UNIVERSAL

46-23-4 Globe (Was Mandatory Note 1 of AD-766-5.) Applies to Models GC-1A, GC-1B Aircraft Serial Numbers 33 to 54 Inclusive, Plus 54, 56, 57, 58, 60, 61, and 64.

FIGURE 1

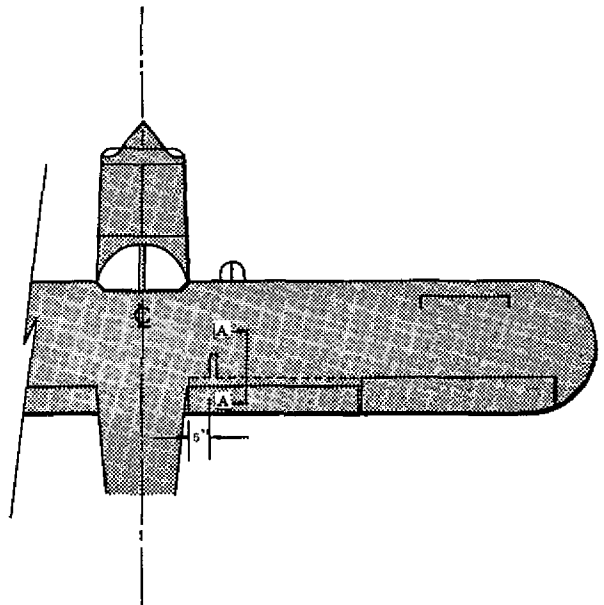
To prevent accidental operation of the fuel shutoff valve during flight, a safety device must be installed on this control. The device is to prevent inadvertent operation of the fuel shutoff valve by requiring a definite and positive movement by the pilot before the control can be operated. Taylorcraft P/N B12-947-3 or equivalent is considered satisfactory. P/N B12-947 which was previously installed in some Taylorcraft airplanes must be replaced by this improved part.
